The Commission has issued the enclosed Amendments Nos. 66, 66 and 63 for Licenses Nos. DPR-38, DPR-47 and DPR-55 for the Oconee Nuclear Station, Units Nos. 1, 2 and 3. These amendments consist of changes to the Station's common Technical Specifications and are in response to your request dated September 18, 1978, as supplemented September 25, and November 1, 1978.

These amendments revise the Technical Specifications to support the operation of Oconee Unit No. 2 at full rated power during Cycle 4 after core reload and removal of the orifice rod assemblies from the core. The amendments also revise the Technical Specifications for Units 1, 2 and 3 in regard to control rod operability.

OCONEE NUCLEAR STATION, UNIT NO. 1

Amendment No. 66
License No. DPR-38

OCONEE NUCLEAR STATION
Figure 2.1-2B

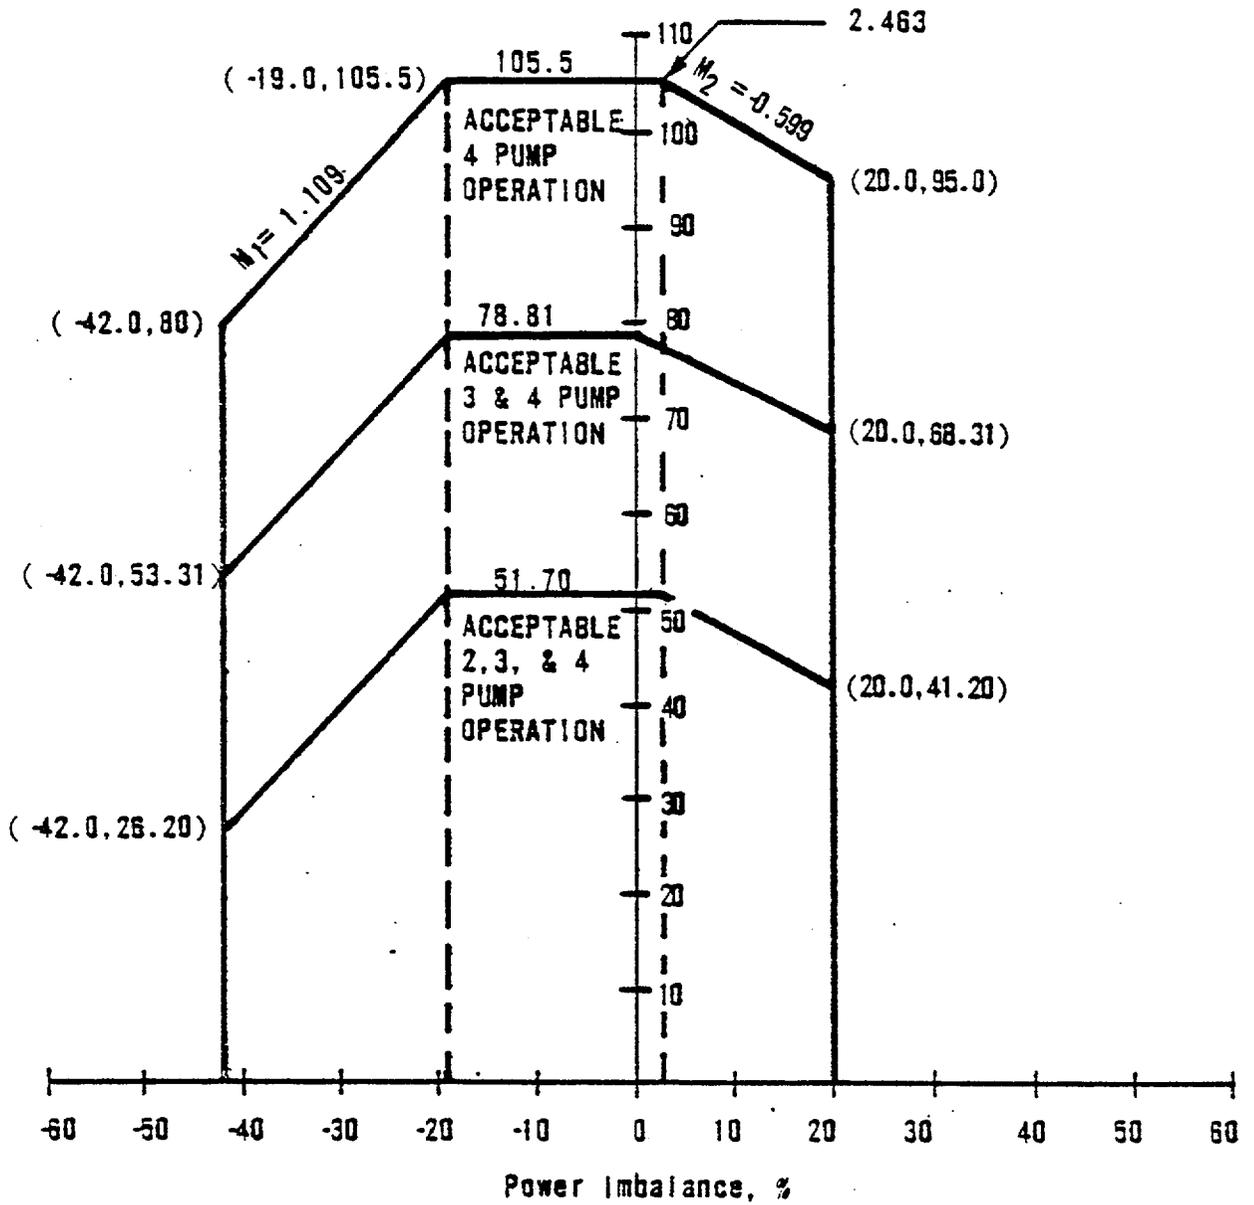
The curves of Figure 2.1-2B are based on the more restrictive of two thermal limits and include the effects of potential fuel densification and fuel rod bowing:

The specified flow rates for Curves 1, 2, and 3 of Figure 2.1-2B correspond to the expected minimum flow rates with four pumps, three pumps, and one pump in each loop, respectively.

1. Modification to Core Protection Safety Limits
(Figure 2.1-2B)*
2. Modification to Protective System Maximum Allowable Setpoints
(Figure 2.3-2B)
3. Modifications to Rod Position Limits
(Figures 3.5.2-1B1, 1B2, 2B1, and 2B2)
4. Modifications to Operational Power Imbalance Envelope
(Figures 3.5.2-3B1 and 3B2)
5. Modifications to APSR Position Limits
(Figures 3.5.2-4B1 and 4B2)
6. Reduction in $F\Delta H$ from 1.78 to 1.71
7. Increase in the allowed steady state quadrant tilt to 5%
and in the linear heat rate peaking increase associated
with positive tilt to 7.50%.
